Drawing to accompany objection from Ian Dench and Virginia Garcia to application 2020/4336/P

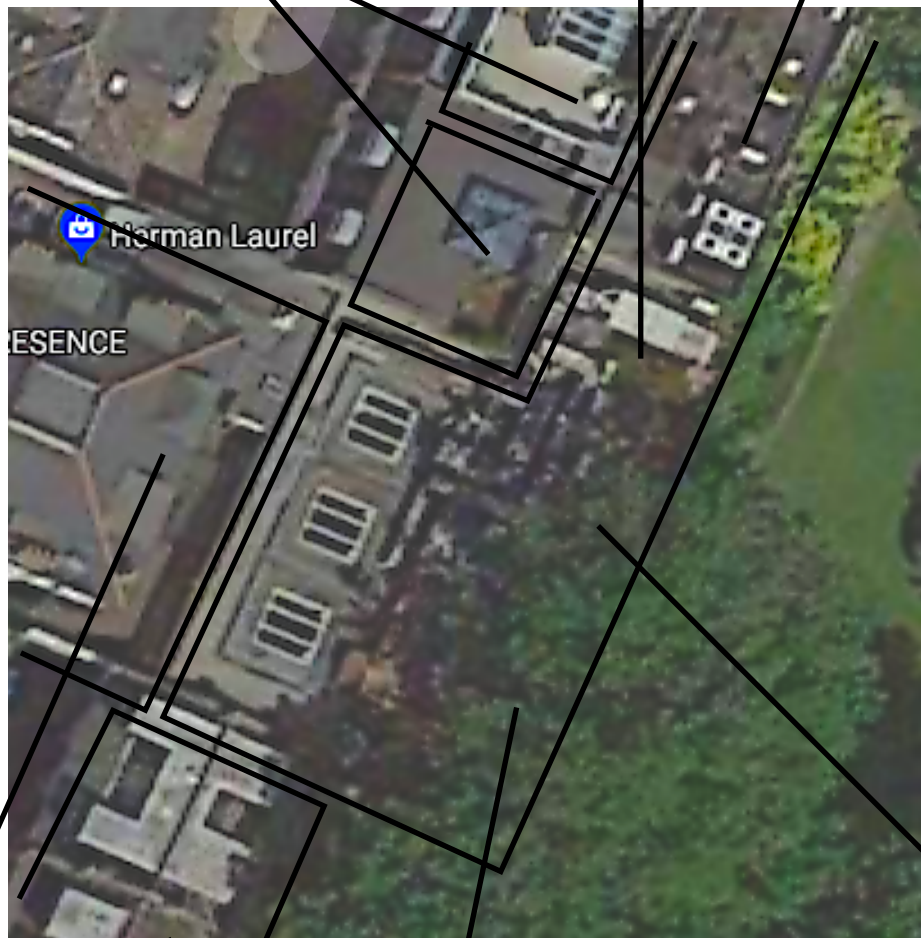
The existing air-handling unit AHU/02 is right next to our bedroom and roof terrace at 12 Lancaster Stables. It caused a lot of noise and vibration

There is space on the flat roof to place any plant a reasonable distance from habitable spaces to minimise the noise and vibration impacting all the adjacent living spaces.
